EPSON PRODUCT SUPPORT BULLETIN

Date:	04/20/2009	Originator:	JAM
PSB #:	PSB.2009.06.001	Authorization:	<i>Kas</i>
Reference:	TI 09-05e Rev. A/B	Total Pages:	5
Product(s):	PowerLite 735c / Cinema 500 / 737c / 745c / 755c / 765c / 830p / 835p / 1705c / 1715c / 6100i / 6110i / 7800p / 7850p / 7900NL / 8300i / 8300i with EasyMP.net module / 9300NL / 1815p / 1825 / 822p / 83c / 822+ / 83+ / G5000 / Pro G5150 / Pro G5350 / Pro G5200W / 1725 / 1735W / 400W / 410W / 84 / 85 / 825 / 826W PowerLite 61p / 81p / 82c / 821p / 1810 / 260d (Latin America) / 280d (Latin America) with TCP/IP to Serial converter		
Subject:	Release of EMP Monitor for Windows version 4.30

EMP Monitor V4.30

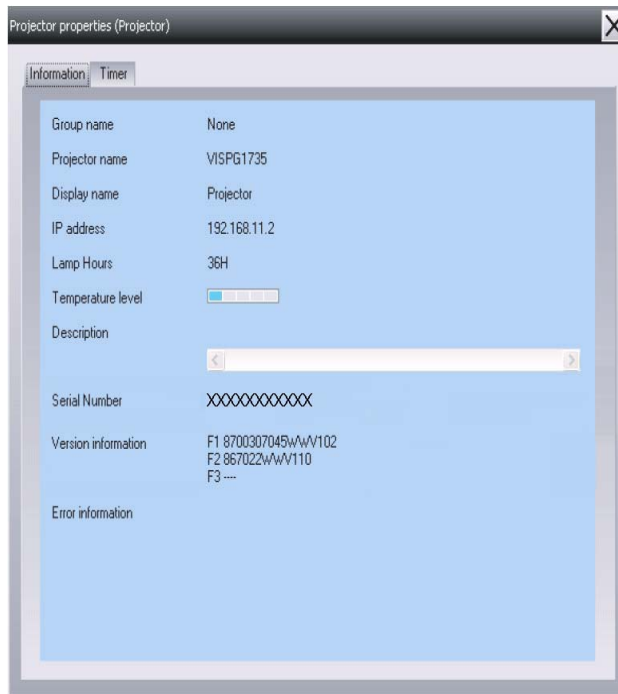
(2) Addition of Input Source (Only PowerLite 84 / 85 / 825 / 826W)
Previous version of EMP Monitor included USB Display, USB and LAN as one source: EasyMP.

The input source buttons for USB display, USB, and LAN are available as separate input sources as shown below:
